| TITLE | WIRE CLAMP |
| DWG NO. | SWA10A-700 |

WORK ORDER NON-CONFORMANCE / ROUTE UPDATE

| Job: _____ Part No. SWA10A-700 REV. 4 | | DISPOSITION | DEPARTMENT/PROCESS | | | | |
|--|-------------------------------------|---|-------------------------------------|--------------------------------------|--|-------------------------------------|---|
| Description Work Order Deviation | | Disposition | | | | | |

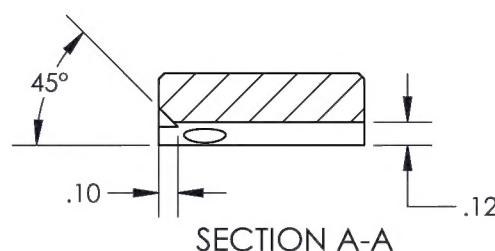
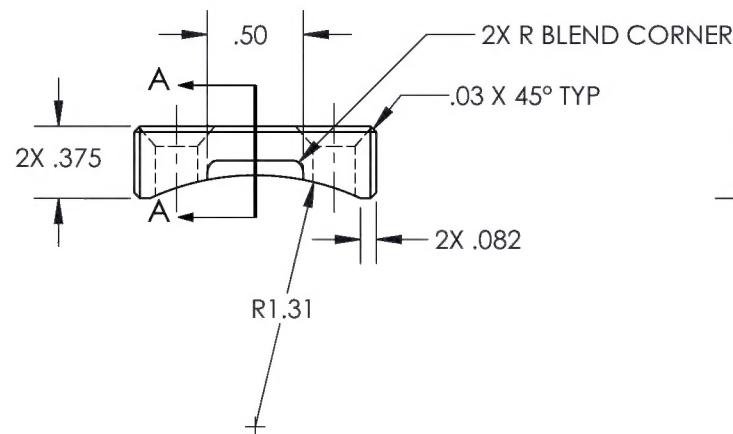
| REVISIONS | | | | | |
|-----------|---------|--|------------|---------|----------|
| 4 | 16-0271 | CH'D DIM WAS 2X R.05 IS 2X R BLEND CORNER. | 12/28/2016 | RJC | JAG |

SEE ATTACHED DEVIATION

| Job: _____ Part No. SWA10A-700 REV. 4 | | DISPOSITION | DEPARTMENT/PROCESS | | | | |
|--|-------------------------------------|---|-------------------------------------|--------------------------------------|--|-------------------------------------|---|
| <p>When assembling a SWA10A-3 it was noticed that the clamping compression of the SWA10A-700 onto the 3 conductor is not adequate.</p> <p>A modified / custom SWA10A-700 with a clamping thickness of 0.175" was used in place of the standard SWA10A-700.</p> | | <p>This deviation is acceptable.</p> <p>The clamping force has been visually verified by A. Patry & M. Lee. <i>3 MBB</i></p> <p>The fit, form, and function of the part will be as originally intended.</p> | | | <p>Completed By</p> <p>Lead hand / Supervisor</p> <p>QC / QA Coordinator</p> | | |
